**PSE&G** Public Service  
Electric and Gas  
Company

August 20, 1984

HOPE CREEK GENERATING STATION  
DOCKET NO. 50-354  
DRAFT SAFETY EVALUATION REPORT  
OPEN ITEM STATUS

Attachment 1 is a current list which provides a status of the open items identified in Section 1.7 of the Draft Safety Evaluation Report (SER). Items identified as "complete" are those for which PSE&G has provided responses and no confirmation of status has been received from the staff. We will consider these items closed unless notified otherwise. In order to permit timely resolution of items identified as "complete" which may not be resolved to the staff's satisfaction, please provide a specific description of the issue which remains to be resolved.

FIGURE 220.21-1  
 RESPONSE SPECTRA COMPARISON,  
 UNIT 1 REACTOR BUILDING AT ELEV. 54' -0".  
 N-S, SSE, 2% DAMPING

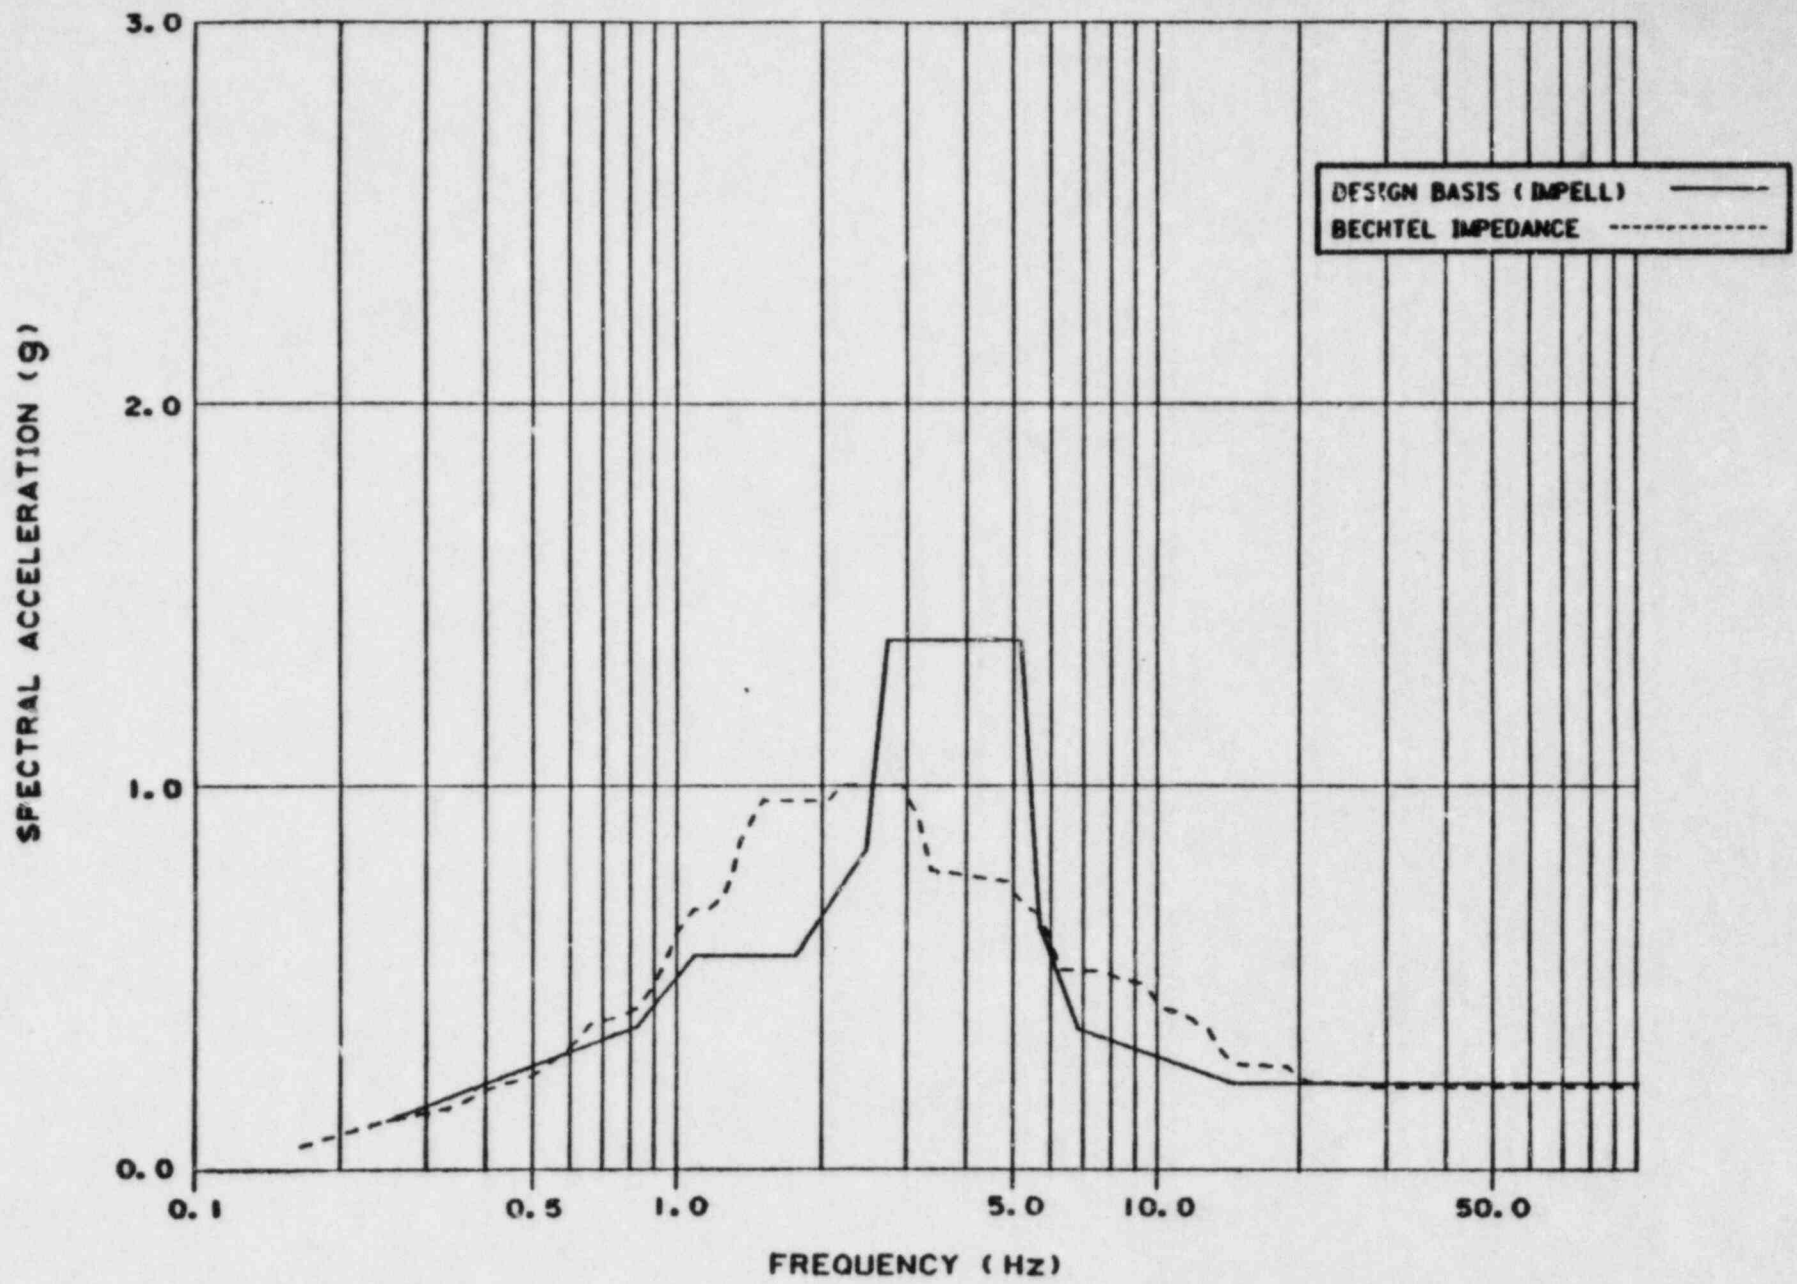
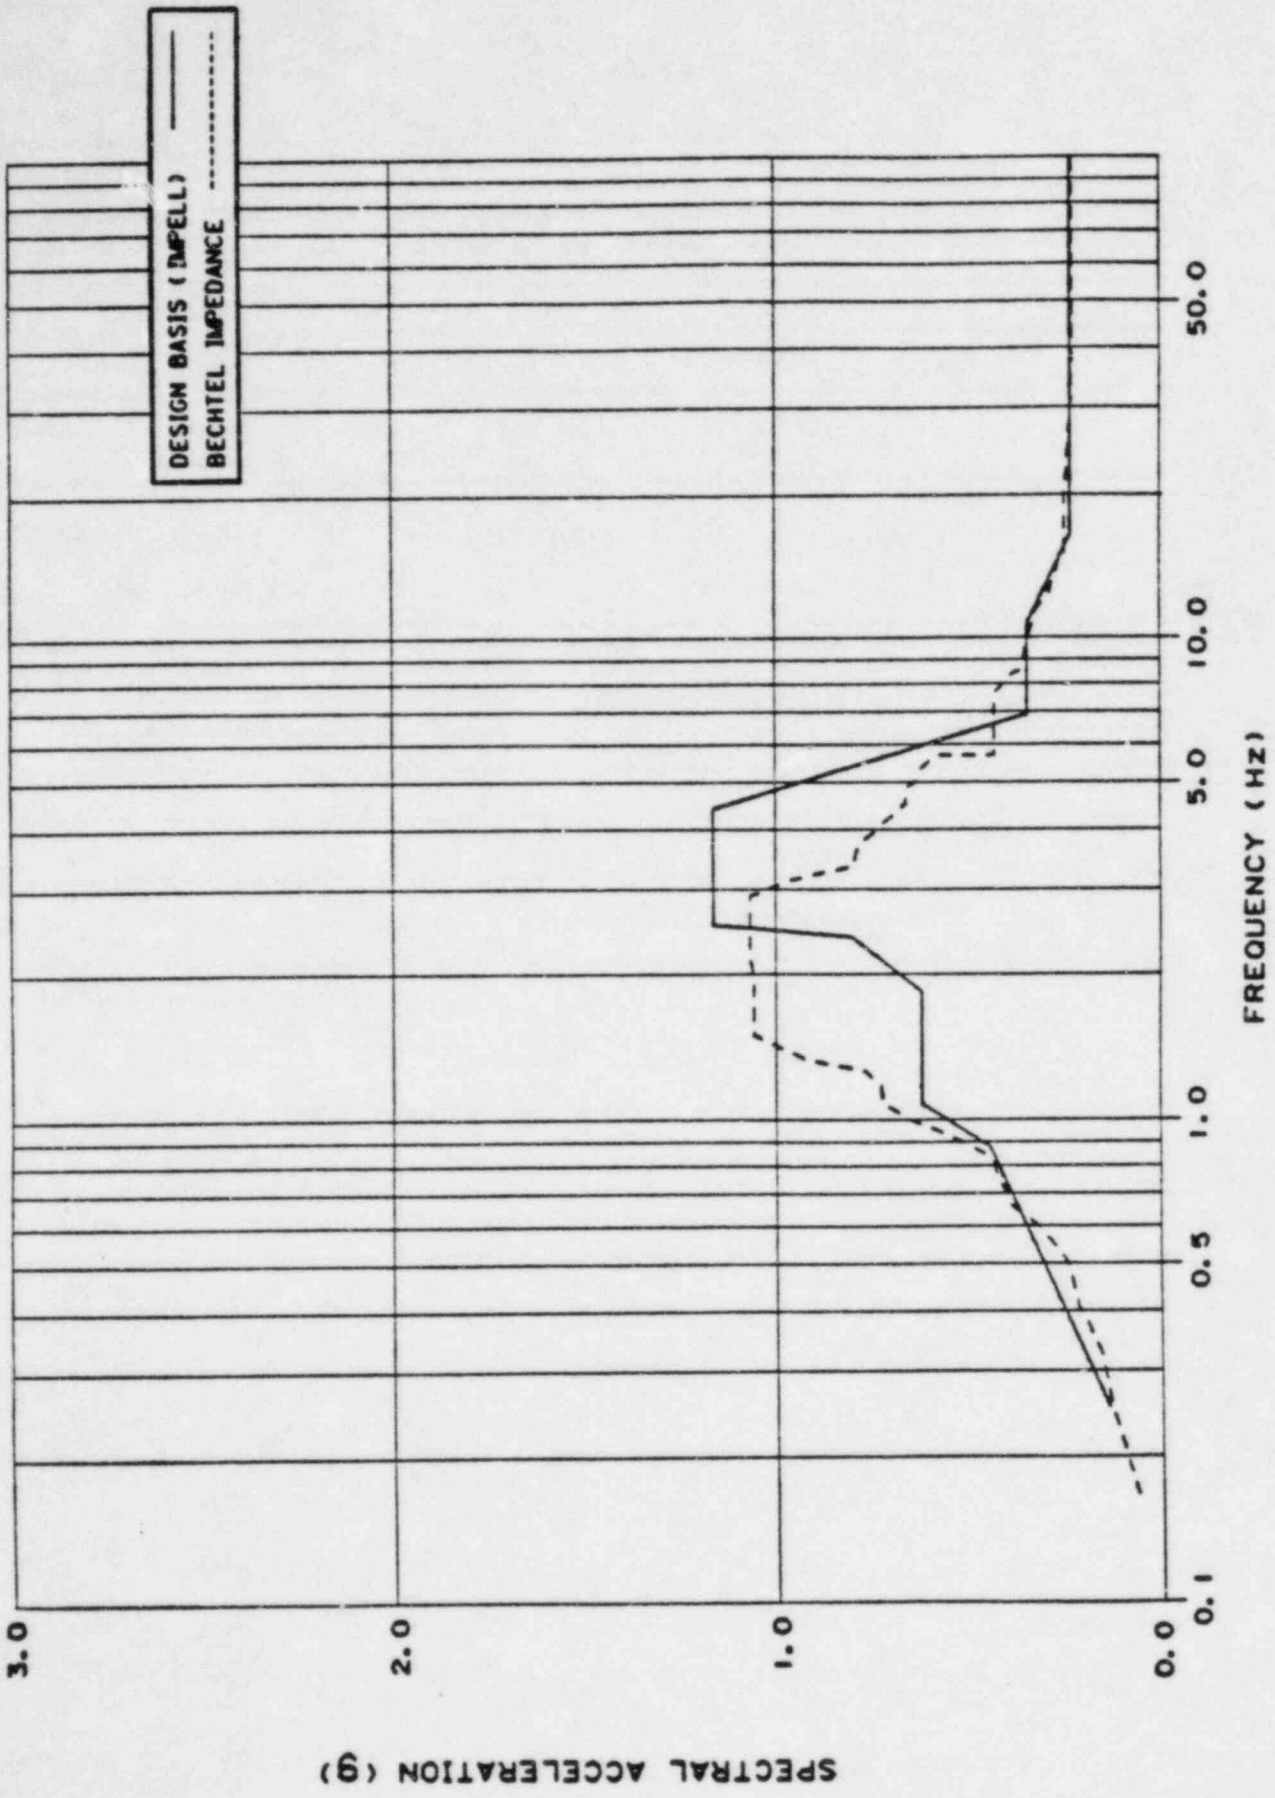
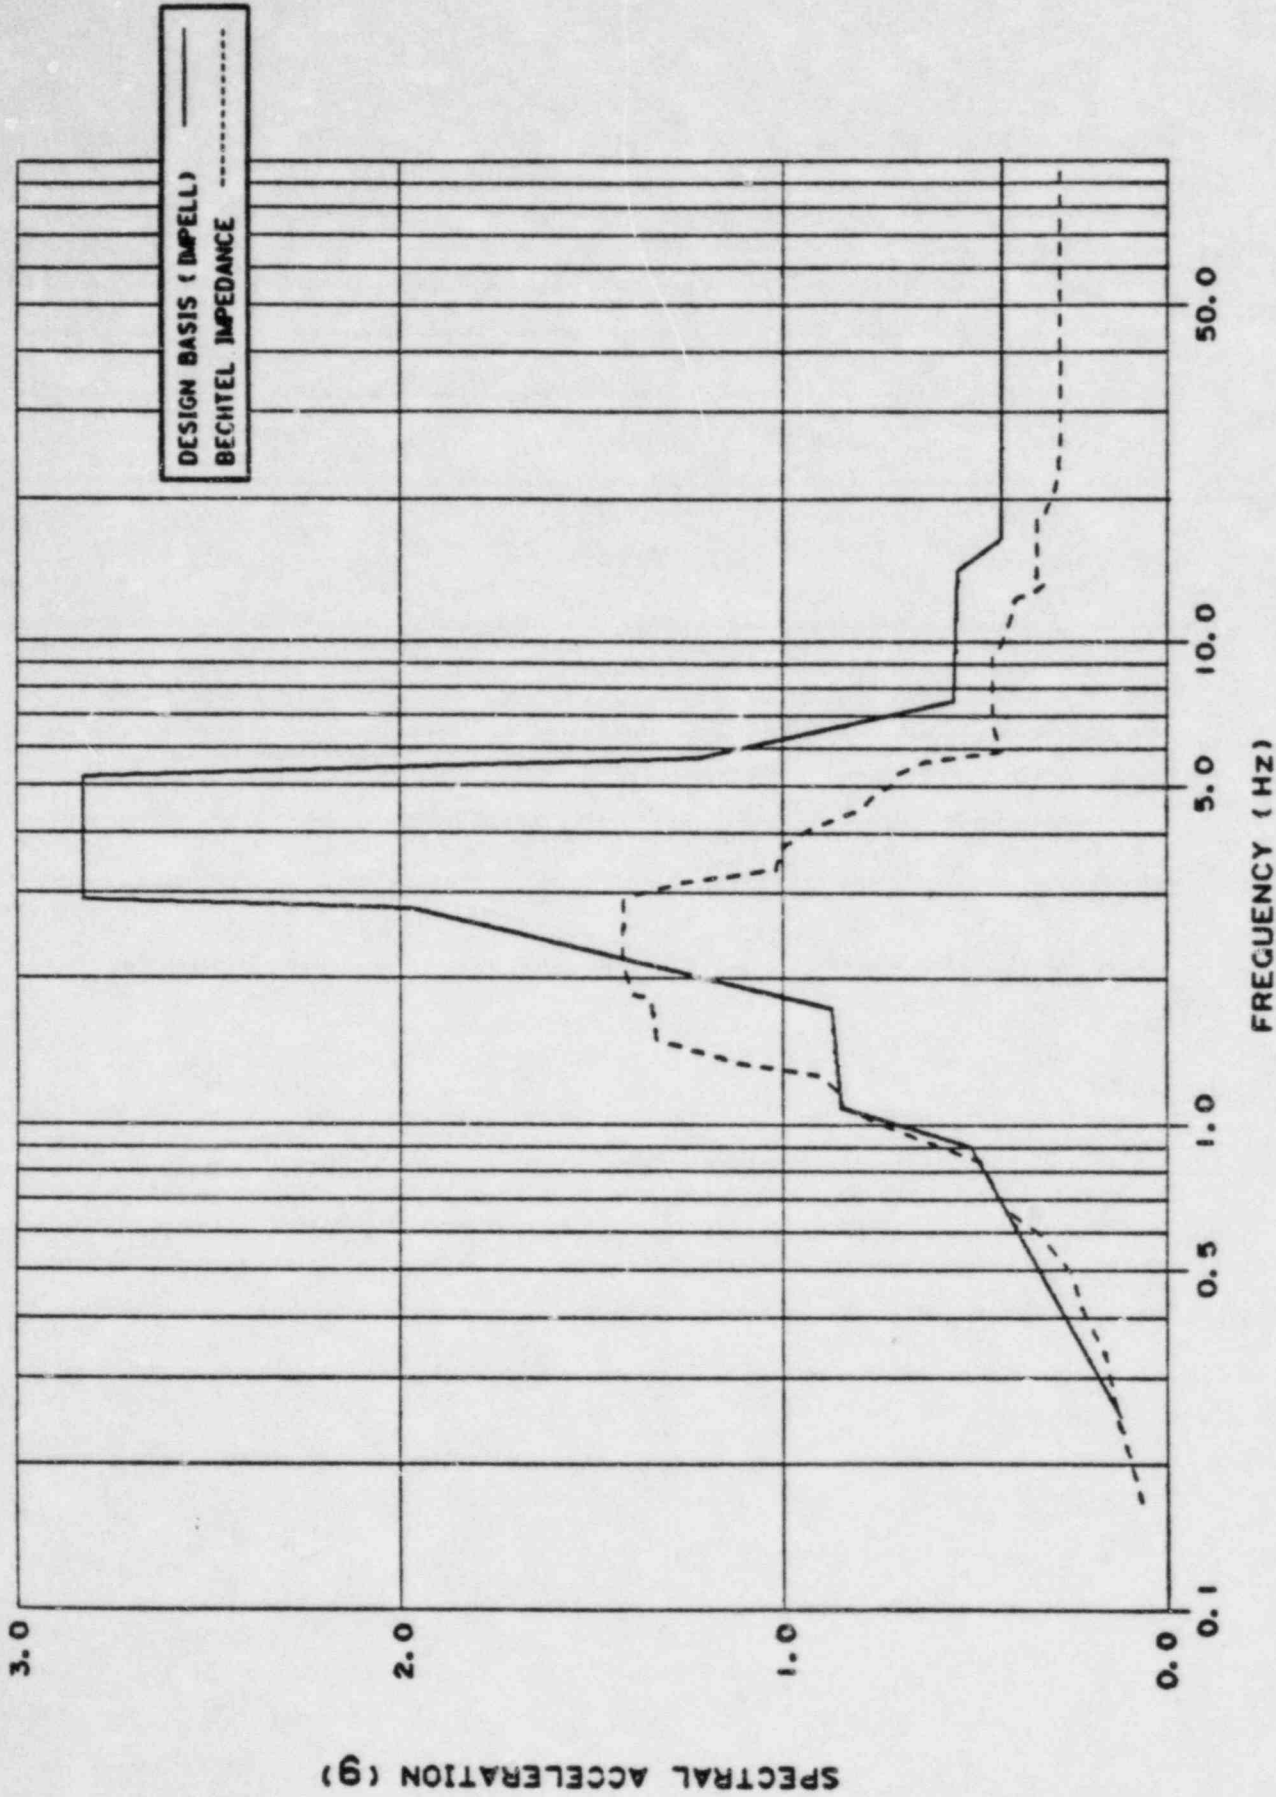
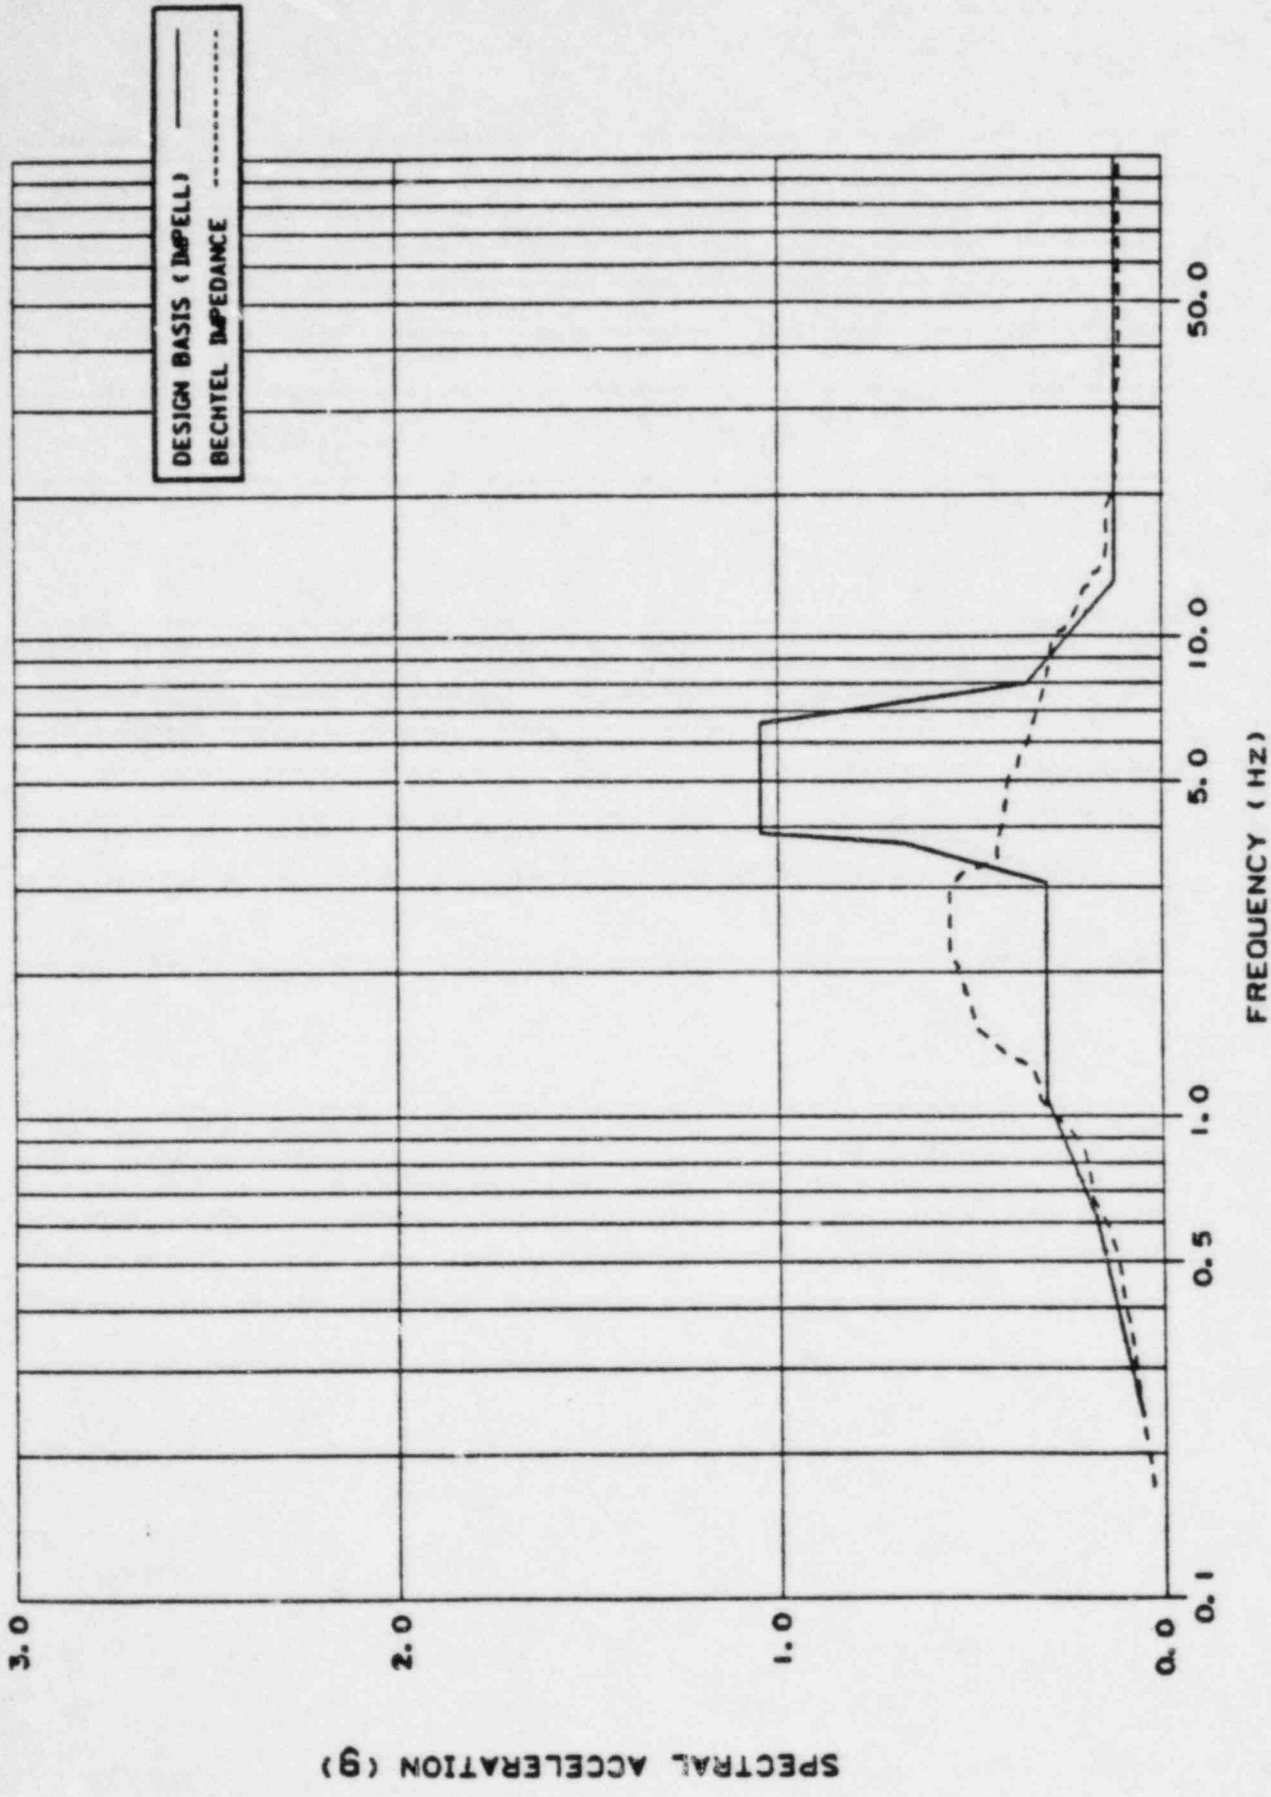
Figures 220.21-1 through 220.21-54 show a comparison of the 2 percent damping response spectra obtained from the design basis finite element and the impedance analyses for the reactor building, auxiliary building and the service water intake structure (SWIS).

¶ For the reactor and auxiliary buildings, the peak spectral accelerations obtained from the impedance analysis are generally lower than those obtained from the design basis analysis. However, the impedance analysis response spectra are not completely enveloped by those obtained from the design basis analysis, especially in the frequency range from 1.0 to 3.5 Hz. Also, there are some local exceedances in the higher frequency range, as shown in Figures 220.21-1 through 220.21-36. ¶ For the SWIS (Figures 220.21-37 through 220.21-54), the impedance analysis response spectra are generally enveloped by those obtained from the design basis analysis at elevation 114.0 feet. For other elevations, the impedance analysis spectral accelerations exceed the design basis spectral accelerations in some frequency ranges. These ranges vary approximately between 1.5 and 10.0 Hz.

In all cases, the items reviewed during these sampling studies can accommodate the loads resulting from the impedance analysis. Therefore, the impedance analysis results have no impact on the plant design.
